VEPCO NOMAD CODE AND MODEL SUPPLEMENTAL INFORMATION.

Docket # 50-280
Control # 8407170305
Date 7/6/84 of Document:
REGULATORY DOCKET FILE

RESPONSE TO QUESTIONS AND COMMENTS ON VEPCO NOMAD CODE AND MODEL (VEP-NFE-1)

1-D TO 3-D AXIAL POWER COMPARISON 13000 MWD/MTU

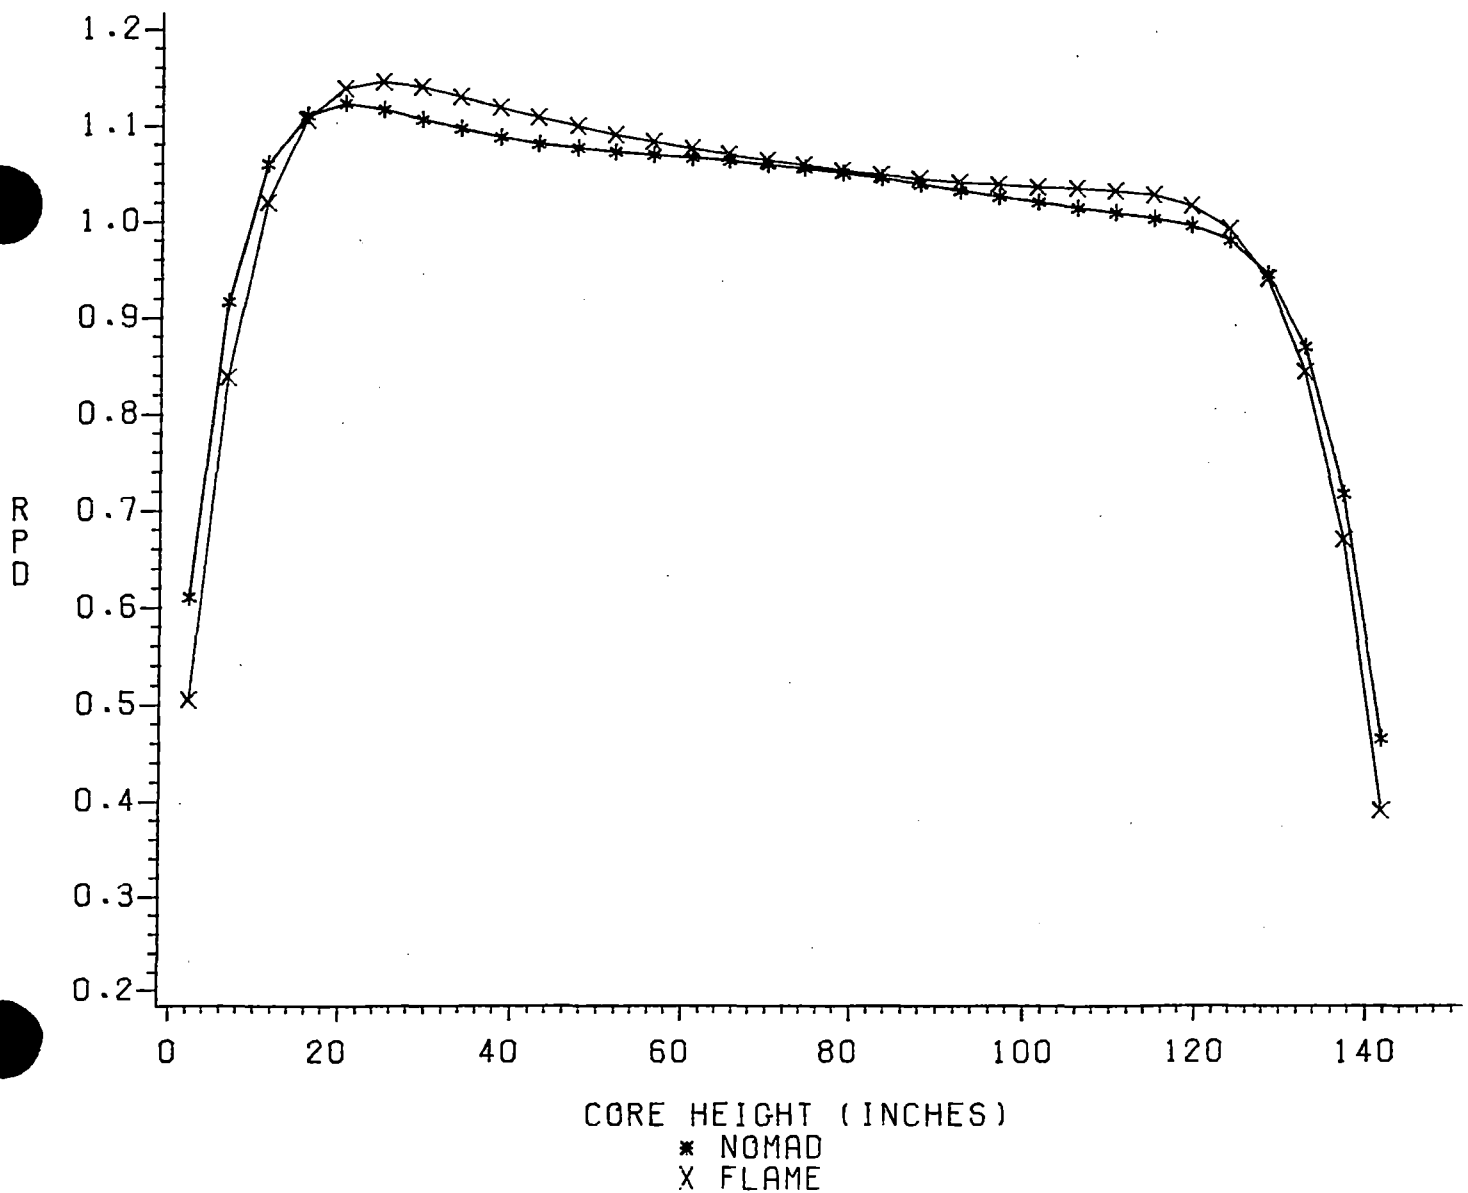
Question 5. The normalization of NOMAD to FLAME solely on the basis of flux difference and mid-plane power in the buckling search seems too limited. In addition, performing the buckling search for rodded configurations with the xenon distribution "frozen at HFP, ARO equilibrium conditions..." does not sound like the right way to do this.

VEPCO's experience has been that axial offset, midplane power and critical boron are sufficient conditions for normalizing NOMAD to FLAME. This is very similar to the 1-D to 3-D normalization methods used by some vendors. Comparisons of NOMAD and FLAME axial power distributions for every burnup step of S1C7 are presented in Figures 5.1 through 5.11. The maximum difference between NOMAD and FLAME is 2.9% for these cases.

FIGURE 6.1

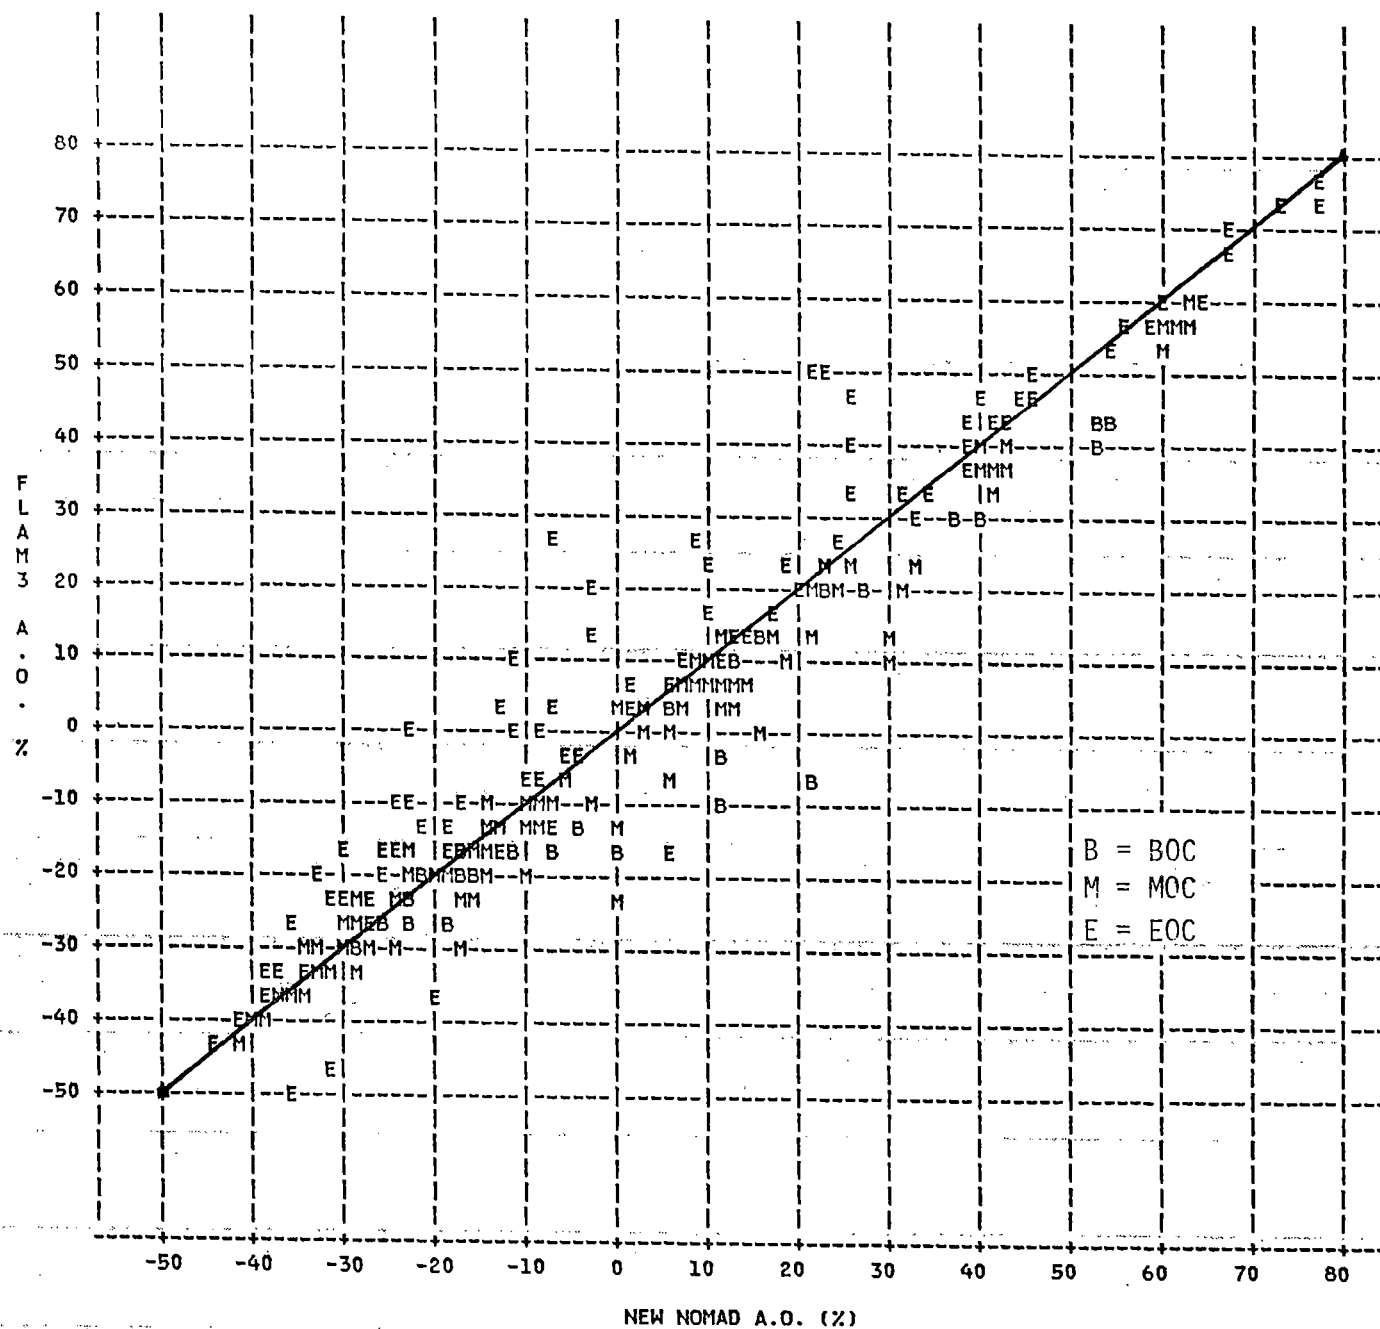
Question 6. What is done vis-a-vis the buckling for intermediate rod/power configurations?

The HFP, ARO buckling coefficients B0 and BTILT are automatically adjusted by NOMAD to compensate for intermediate rod/power configurations. VEPCO has found that adjusting the buckling coefficients in this manner provides excellent results compared to 3-D FLAME calculations at intermediate rod/power configurations. Figure 6.1 shows the correlation between NOMAD

and FLAME for a variety of power levels, rod insertions, and xenon conditions when this buckling adjustment is used. These cases were performed for two Surry and two North Anna cycles for the following range of conditions: BOC, MOC, and EOC burnups; 0, 25, 50, 75, and 100% power; no xenon, equilibrium xenon, and xenon frozen at HFP, equilibrium conditions; and control rods inserted from 0 to 67%. Figures 6.2 through 6.7 show the NOMAD results obtained with this new buckling adjustment for the three load follow maneuver simulations previously presented in Section 5.6 and Figures 5-33 through 5-38 of the NOMAD Topical Report. This methodology replaces the deep insertion control rod model described in the NOMAD Topical Report.
